Introduction of improved plug connector in 117- CSR electrical equipments

Fig.1 New connector and old connector for 117 CSR electrical equipment

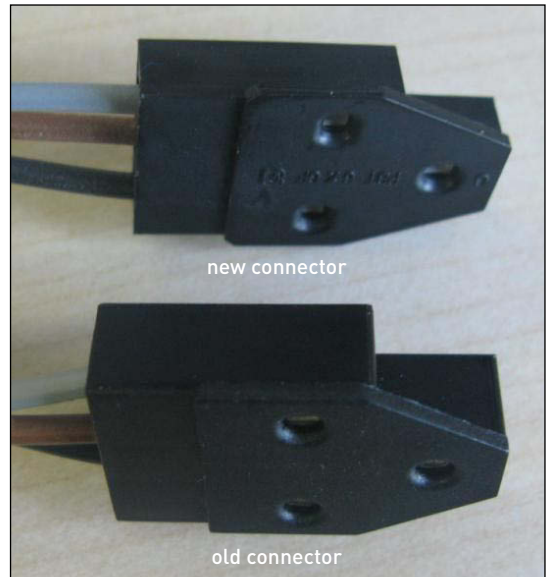
This equipment concerns SC compressors. The general size of the new plug is similar to the previous one. In Fig.1 you can see the new terminal plastic box with different shape holes and a smaller size for the Fusite® pin holes.

The reason for smaller holes in the plastic box is to obtain a more straight push on direction. Push-on force is thus slightly increased compared to the old type.

Fig.2 Tighter cluster contacts

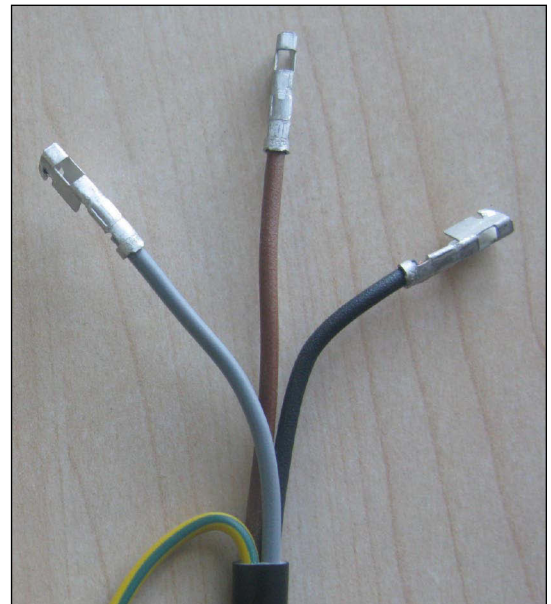
The cluster contacts (Fig.2), currently used for inside our motor connection to the Fusite®, are now used with the new terminal box.
